Access Compliance Report
Public Rights-of-Way
(Curb Ramps)

Intersection ID: 50938	Main Street: BLAIRBETH_ST	Cross Street: CANMORE_ST	Location:	NW
ADA ID: 424BD9BE7715	Ramp Type: PerpDiag	Initial Pass/Fail: Fail	Overall Compliance: No	Severity Score: 13.75

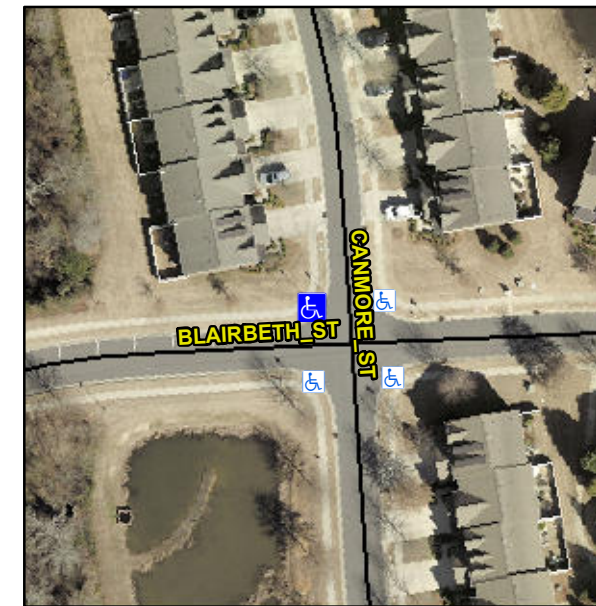
Not Found, R304.2.2, R304.5.3

Compliance	Description	Data	Compliance	Description	Data
N/A	Ramp Length (in)	47.0	No	Ramp Slope (%)	8.5
Yes	Ramp Width (in)	48.0	No	Ramp XSlope (%)	2.3
N/A	Flare Type LT	N/A	N/A	Flare Type RT	N/A
N/A	Flare Slope LT (%)	N/A	N/A	Flare Slope RT (%)	N/A
N/A	Flare Traversable LT?	N/A	N/A	Flare Traversable RT?	N/A
N/A	Landing Length (in)	N/A	N/A	DWS Provided?	N/A
N/A	Landing Width (in)	N/A	N/A	DWS Contrast?	N/A
N/A	Landing Slope (%)	N/A	N/A	DWS Length (in)	N/A
N/A	Landing X Slope (%)	N/A	N/A	DWS Full Width?	N/A
N/A	Landing Curb? (Y/N)	N/A	N/A	DWS Offset (in)	N/A
N/A	Shared Landing?	N/A			
N/A	Gutter Ponding?	N/A	N/A	Gutter Slope (%)	N/A
N/A	Gutter Lip Ht (in)	N/A	N/A	Gutter X Slope (%)	N/A
N/A	Painted X Walk1?	No	N/A	Painted X Walk2?	No
	X Walk 1 Direction	To S		X Walk 2 Direction	To E
N/A	X Walk 1 Width (in)	N/A	N/A	X Walk 2 Width (in)	N/A
	X Walk 1 Slope (%)	1.5		X Walk 2 Slope (%)	2.6
	X Walk 1 X Slope (%)	1.5		X Walk 2 X Slope (%)	0.2

Remove & Replace Curb Ramp With Two New Directional Ramps or Equivalent.
